File Number: 9-C-25-IH

Location: 225 E. Oldham Ave. **Parcel ID:** 81 K H 020
Zoning: RN-2 (Single-Family Residential Neighborhood)
Description: After-the-fact revisions to 11-H-24-IH

After-the-fact revisions to COA 11-H-24-IH. Revisions include:

Elevation B - B Scale: 1/4" = 1'-0"

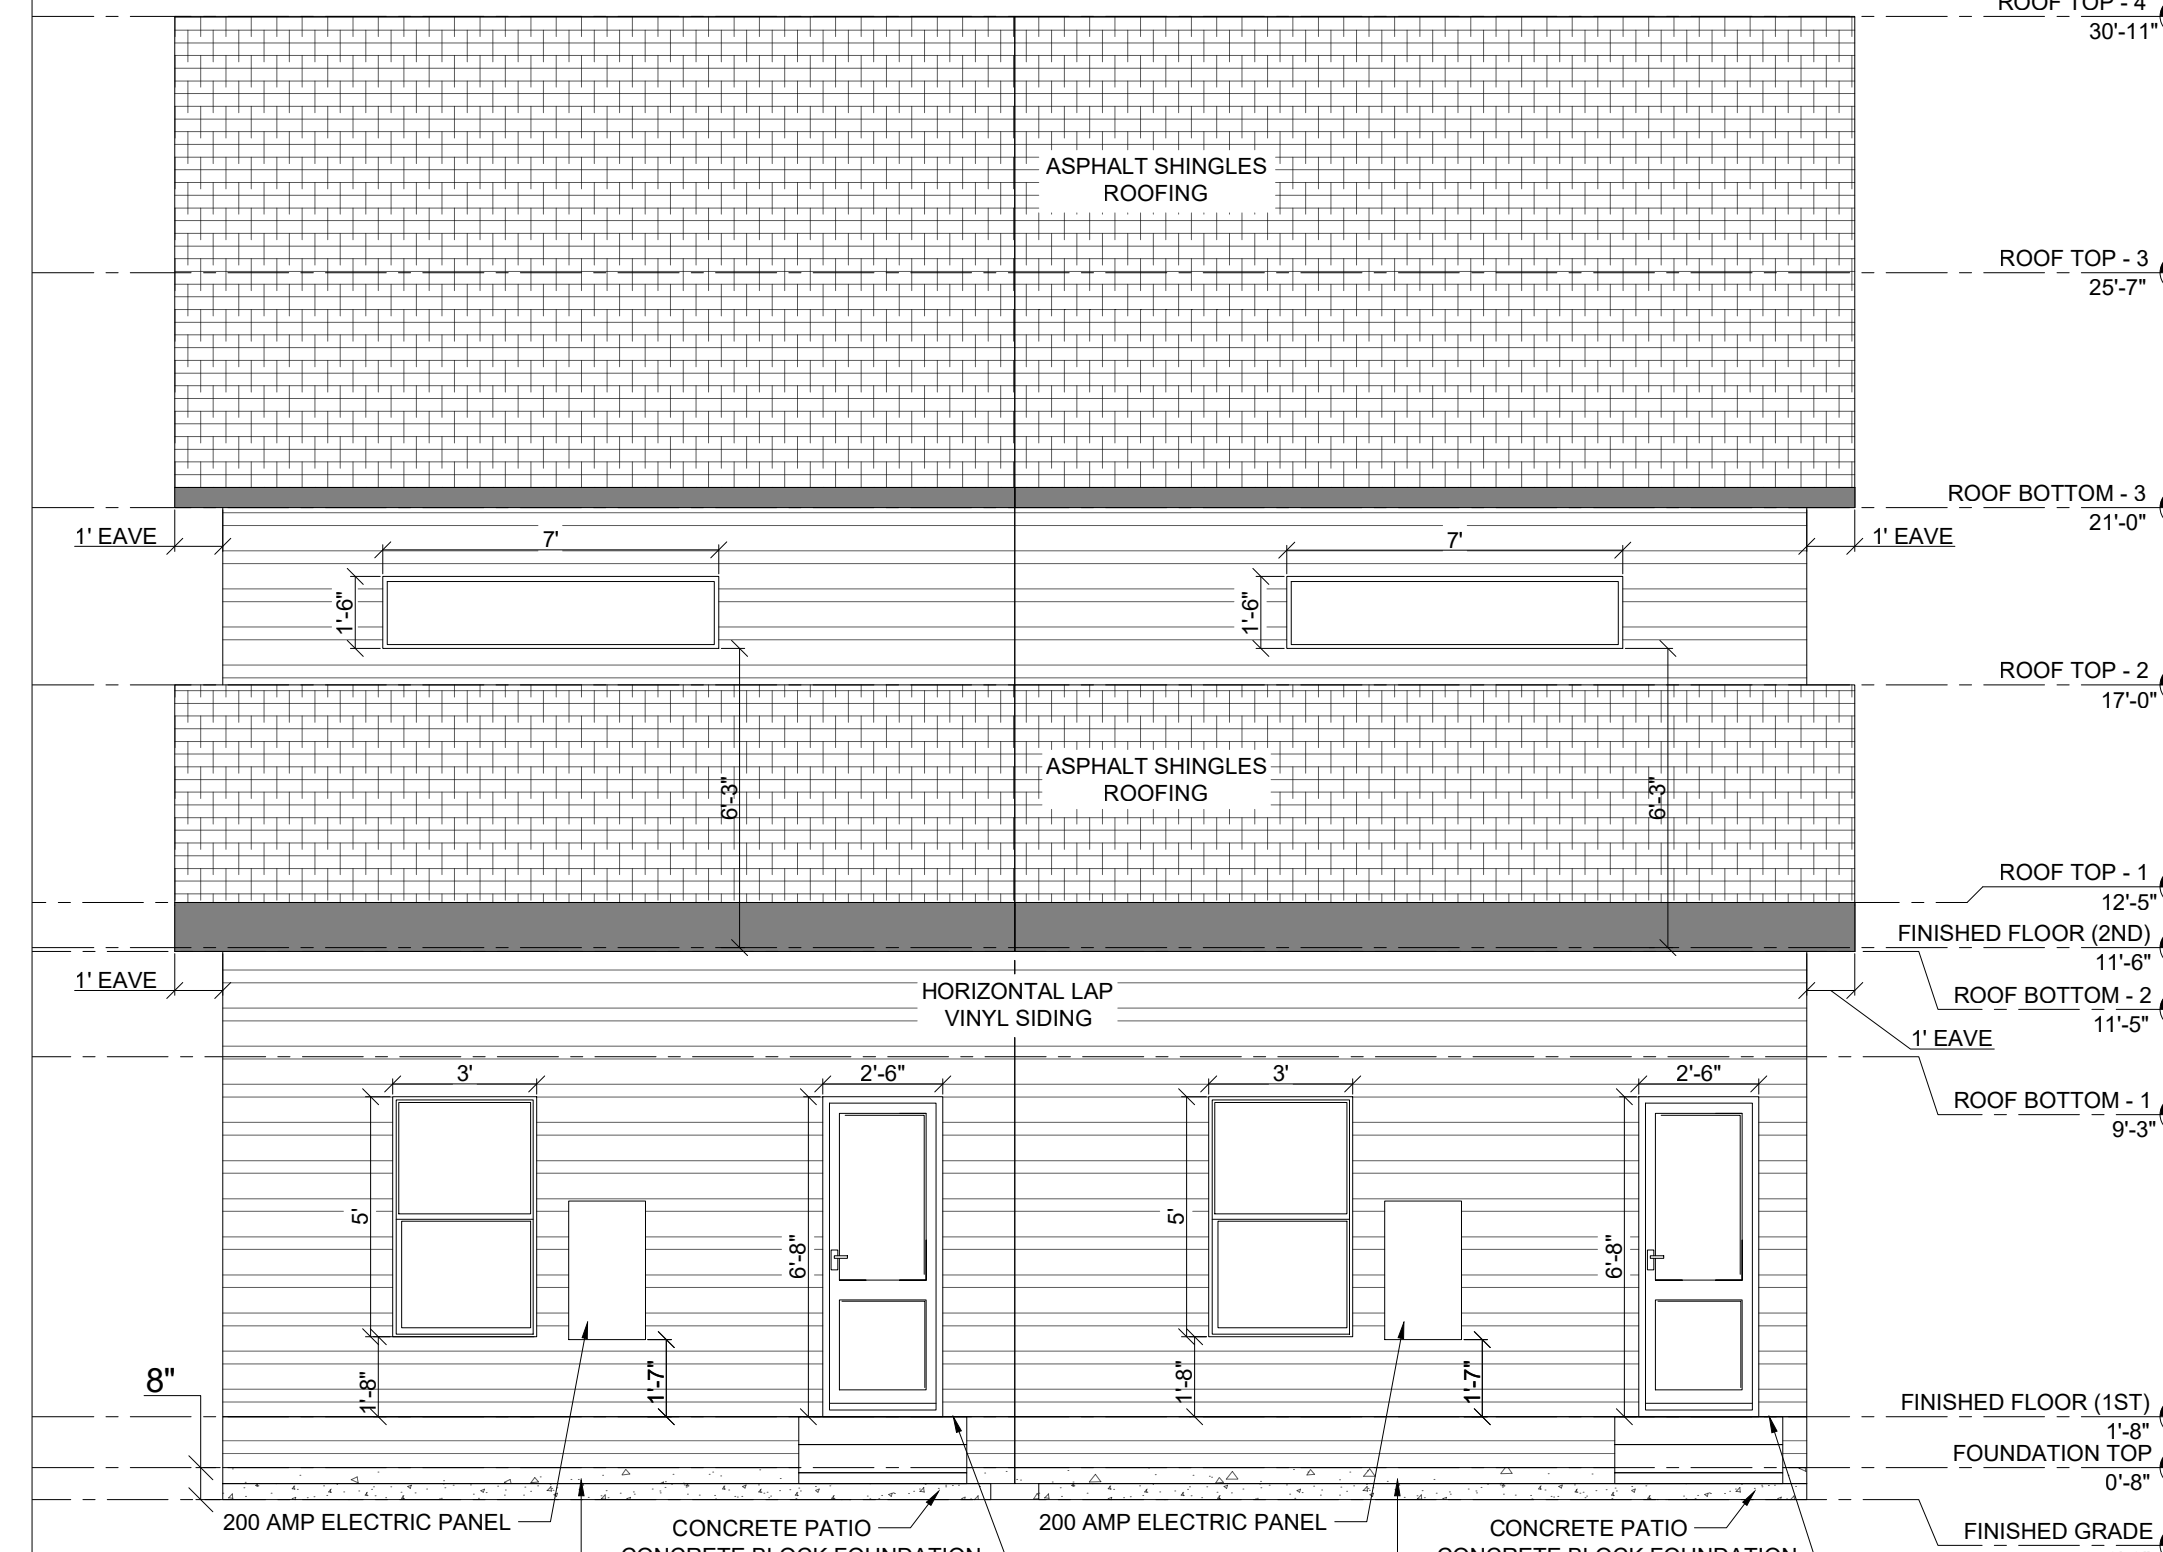
4. Design guidelines recommend that foundation heights “be comparable to historic houses in the neighborhood,” and most of the houses on this side of East Oldham Avenue feature raised foundations to account for the slope. The permit-approved plans included a 1’-8” tall foundation measured at the façade. The applicant reached out to staff in February soon after the permit was issued to request approval to increase the foundation to approximately 3.5’, which staff approved since the height was comparable to the other houses on the block. However, the building was constructed with a 7’ tall foundation at the façade, making the structure significantly tall in scale with the block that only features one-story houses. The Board should discuss whether shrubs (such as hydrangea, azaleas, rhododendron, or boxwood) should be planted at the sides of the foundation near the corners of the façade to screen the foundation, in addition to the proposed planter boxes.
